RE: Draft Phase I RFI/RI Workplan for OU 3, the Off-site Areas,
July, 1991

Review and Comment

Draft RFI/RI Workplan for OU 3 - Offsite Areas
July, 1991

FIGURE 6A

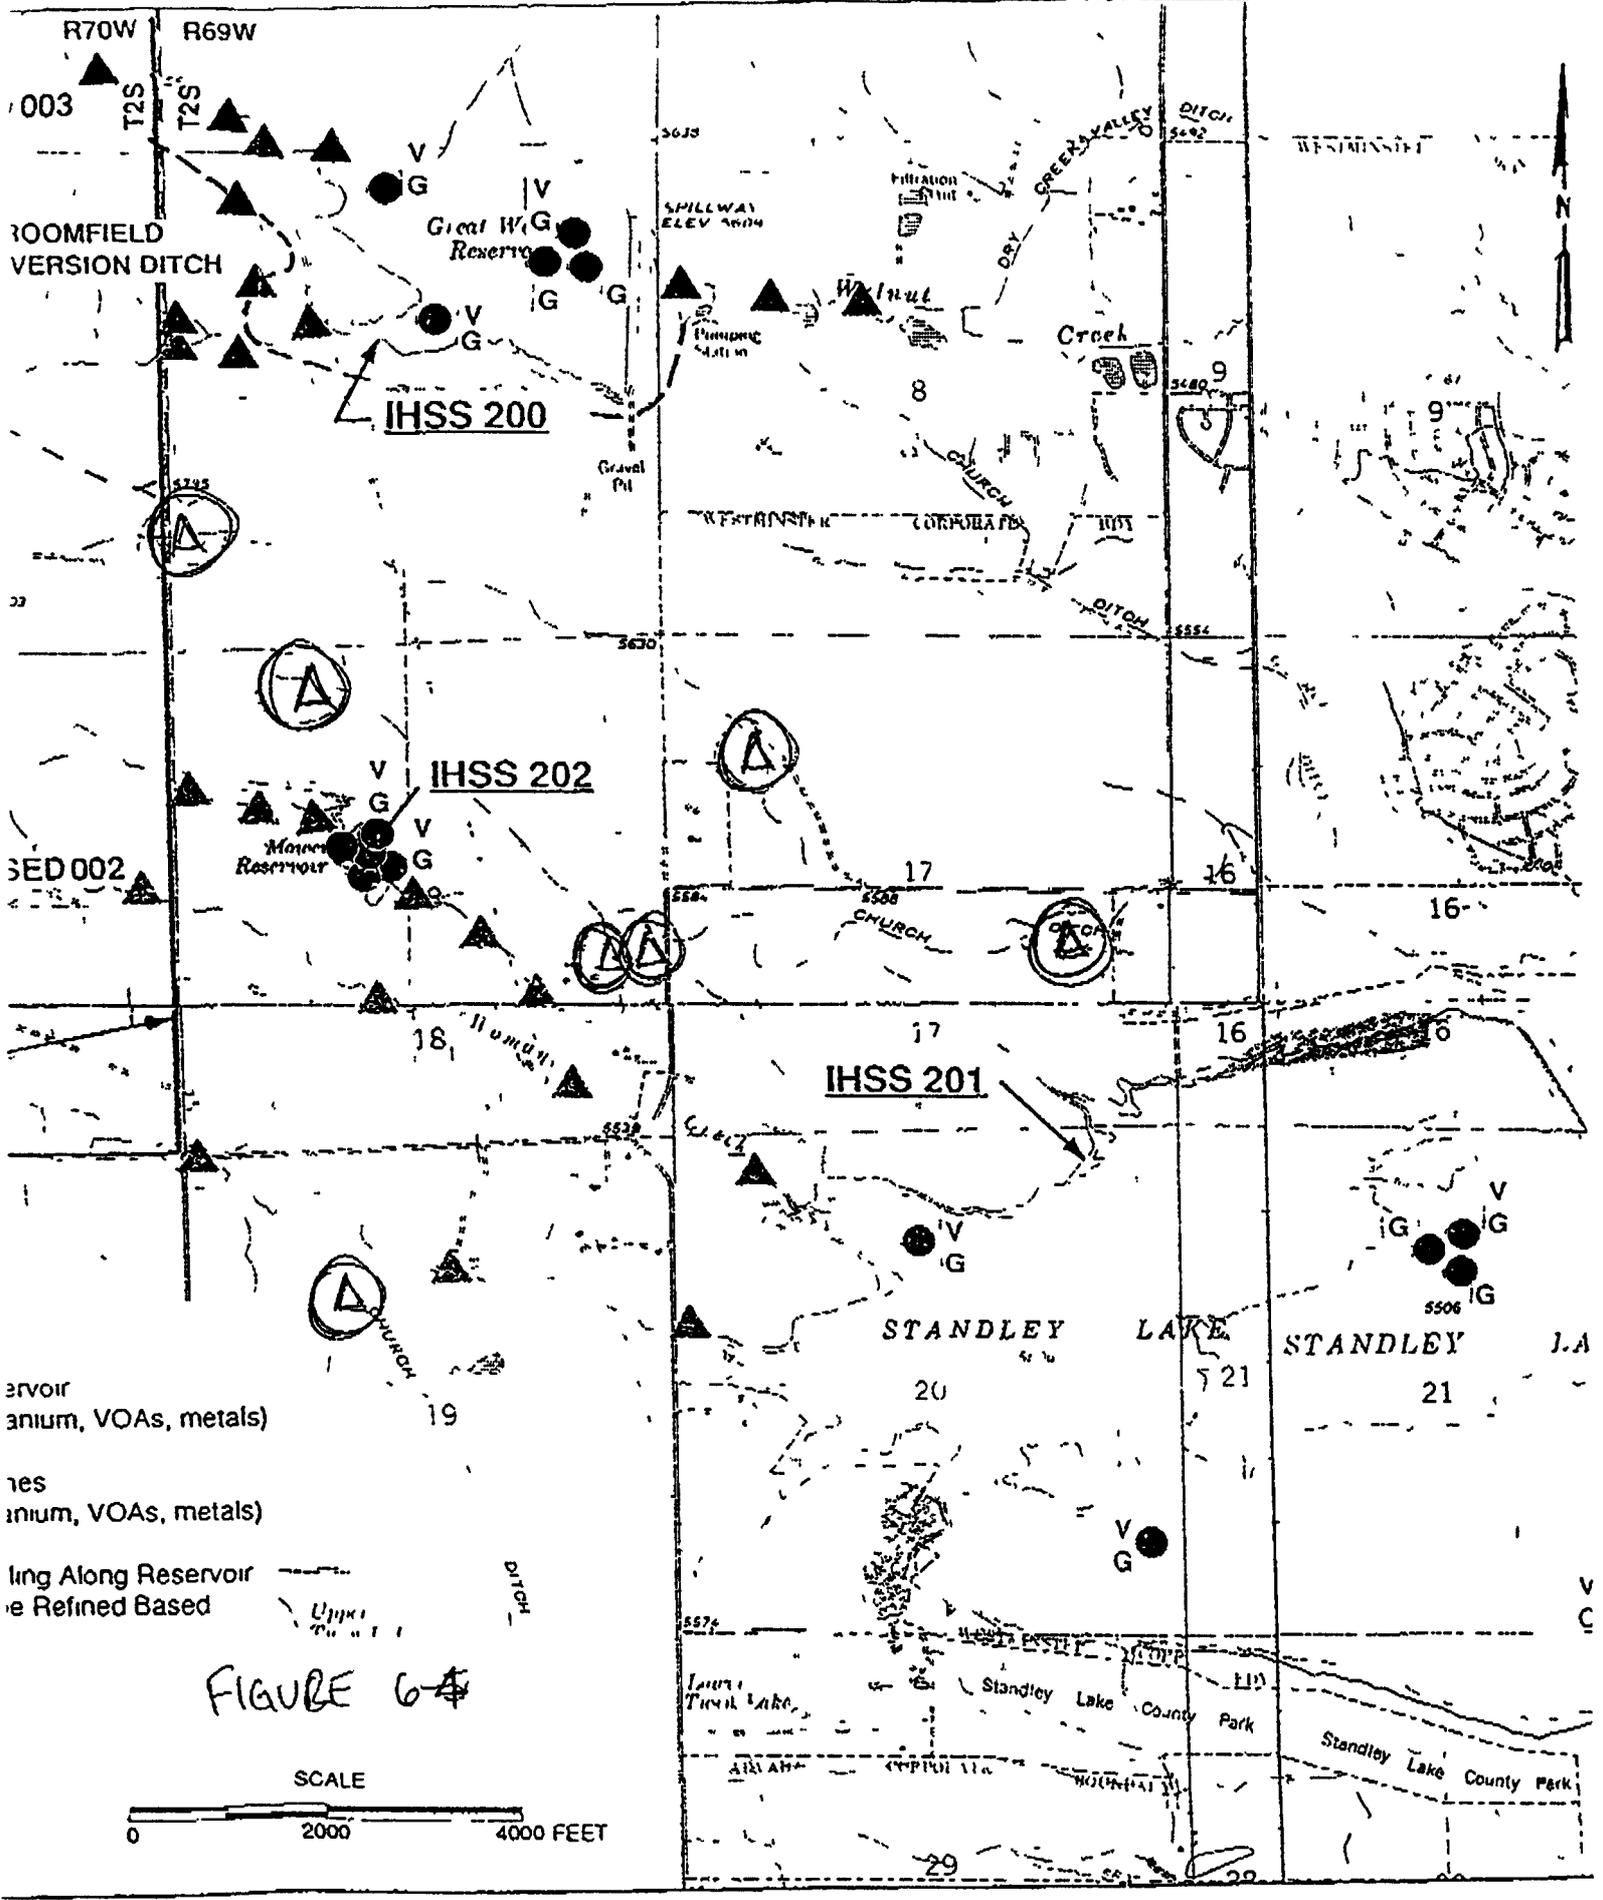
Figure 6-4: Please refer to the attached copy of Figure 6-4 for the Division's recommendation for additional sampling locations.

Please note that the additional sampling locations are within Church Ditch (3 samples), and the two ephemeral streams northeast of Mower Reservoir (4 samples). The Division believes these samples are justified because 1), these sediment locations are directly down the major wind vector from the plant and within the main plutonium contamination plume and 2), no data is currently being collected in these streams to study the collection and concentration role that they may be playing in the migration of plutonium in the surface system.

Figure 6-5: Please refer to the attached copy of Figure 6-5 for the Division's recommendation for additional sampling locations.

These sample locations have been added for reasons similar to those stated above for the additional sediment sampling locations. These additions are necessary to gain a complete understanding of the surface water system.
